CITY OF ROCKVILLE HISTORIC DISTRICT COMMISSION STAFF REPORT

May 15, 2001 MEETING NO. 05-01

APPLICATION: HDC01-0190

ADDRESS: 111 Jefferson Street

Rear porch 111 W. Jefferson Street

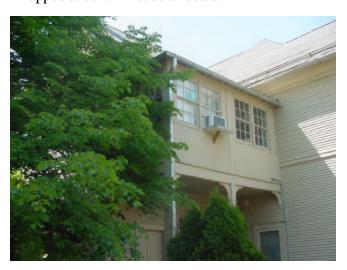
Staff recommends approval of HDC01-0190 to remodel the second floor porch into useable space for an office by replacing windows and matching the material, composition, design and texture to existing windows, and addition of electrical circuits and insulation in the walls below the windows.

The porch is located on the rear (north) side of the house but is visible from Jefferson Street. It abuts the church's parking lot to the north and a driveway on the east. No changes will be made to the first floor of the porch. New window frames on the east and north walls and new siding will be wood and will match existing. Other changes, including additional electrical outlets and a new ceiling light, are interior changes.

STAFF RECOMMENDATION: Staff recommends approval of HDC01-0190 based on the Secretary of the Interior's Standards for Rehabilitation, Number 6, which states that:
